PIC24FJ64GA104 Family Silicon Errata and Data Sheet Clarification

The PIC24FJ64GA104 family devices that you have received conform functionally to the current Device Data Sheet (DS39951C), except for the anomalies described in this document.

FIGURE 2-3 FREQUENCY vs. ESR PERFORMANCE FOR SUGGESTED VCAP

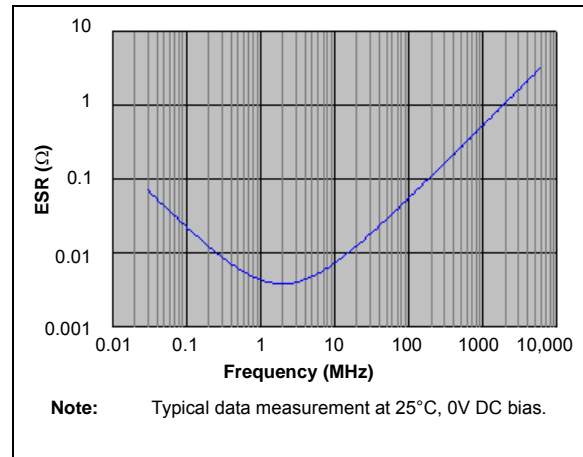
Section 2.4 Voltage Regulator Pins (ENVREG/ DISVREG and VCAP/VDDCORE) has been replaced with a new and more detailed section. The entire text follows:

When the regulator is enabled, a low-ESR ($< 5\Omega$) capacitor is required on the VCAP/VDDCORE pin to stabilize the voltage regulator output voltage. The VCAP/VDDCORE pin must not be connected to VDD and must use a capacitor of 10 μF connected to ground. The type can be ceramic or tantalum. Suitable examples of capacitors are shown in [Table 2-1](#). Capacitors with equivalent specifications can be used.

Designers may use [Figure 2-3](#) to evaluate ESR equivalence of candidate devices.

FIGURE 2-4 DC BIAS VOLTAGE vs. CAPACITANCE CHARACTERISTICS

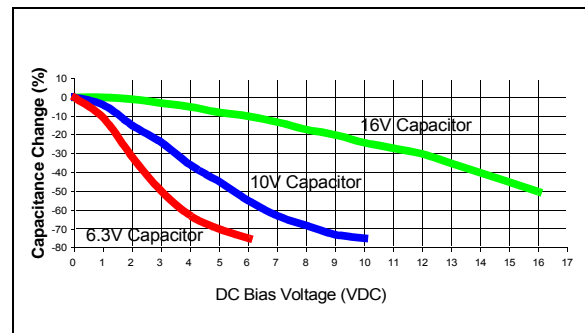
In addition to temperature tolerance, the effective capacitance of large value ceramic capacitors can vary substantially, based on the amount of DC voltage applied to the capacitor. This effect can be very significant, but is often overlooked or is not always documented.

A typical DC bias voltage vs. capacitance graph for 16V, 10V and 6.3V rated capacitors is shown in Figure 2-4.

When selecting a ceramic capacitor to be used with the internal voltage regulator, it is suggested to select a high-voltage rating, so that the operating voltage is a small percentage of the maximum rated capacitor voltage. For example, choose a ceramic capacitor rated at 16V for the 2.5C core voltage. Suggested capacitors are shown in Table 2-1.
